# A1 in Northumberland: Morpeth to Ellingham

**Scheme Number: TR010059**

## **7.6B Statement of Common Ground with Natural England**

June 2021

**Figure 1.** Location of buildings B101A (red) and B84A (blue) in proximity to the proposed West Moor Junction to the northeast.

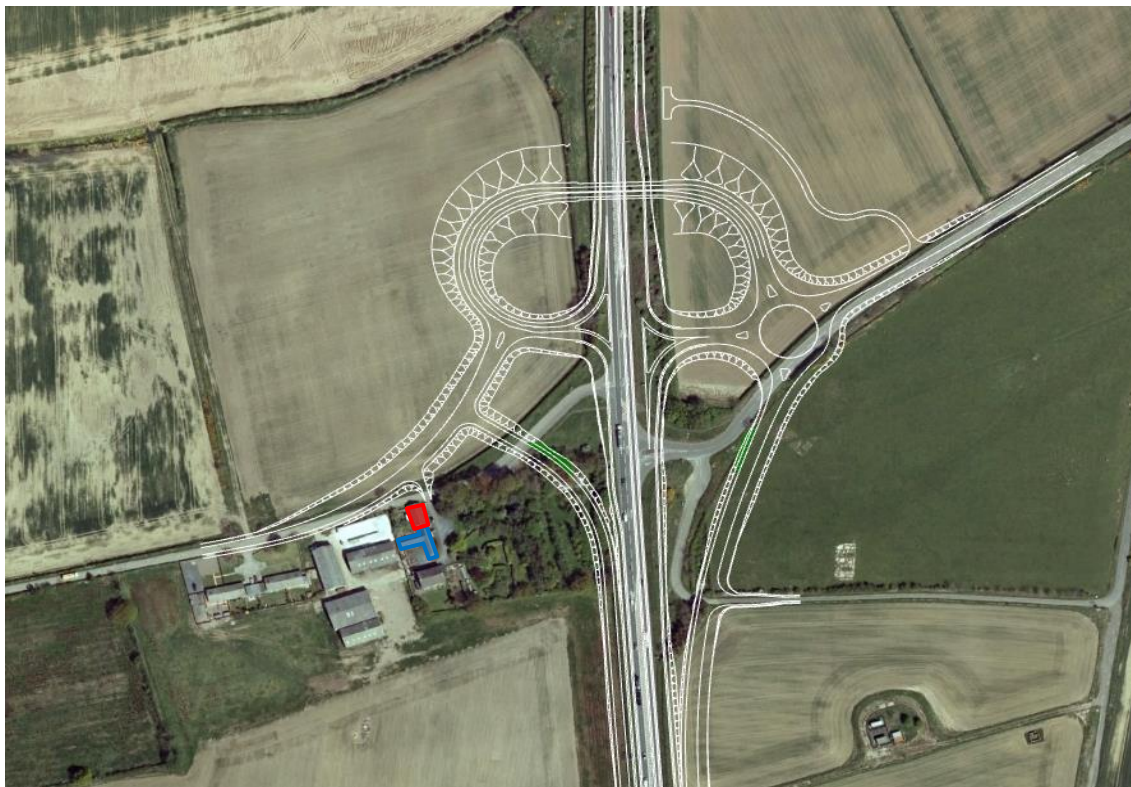
Despite repeated attempts to agree access, permission has not been granted to a single building (referenced as B101A<sup>1</sup>, Figure 1). As such, the below outlines the proposed assumption to inform the impact assessment and mitigation proposals for your review and comment.

The adjacent building to the south (referenced as B84A, Figure 1) supports greater value for bats with multiple PRFs. The building was subject to a Preliminary Roost Assessment (PRA) in 2017 and three emergence/ re-entry surveys, in 2017 (July, August and September). The surveys identified common species roosting within the building; including a single common pipistrelle *Pipistrellus pipistrellus*, a single soprano pipistrelle *Pipistrellus pygmaeus* and a single brown long-eared bat *Plecotus auritus*.

Buildings B84A and B101A are located directly adjacent to a proposed slip road connecting to a new junction (West Moor Junction, hereafter referred to as the 'Junction') approximately 100 m to the northeast (Figure 1). It is considered that during the construction phase, there will be a temporary increase in disturbance due to increased noise and vibration levels. This may result in a potential temporary functional loss of the roosts through desertion during the construction period. Initial intrusive ground works (including any piling) have been scheduled between late September 2020 (28<sup>th</sup>) and January 2021. These works are considered to incur the greatest disturbance impacts and their timing avoids the summer period when bats are known to occupy the roost. The buildings are also not considered to have value for hibernation roosting.

Your comment and response to the above would be much appreciated.
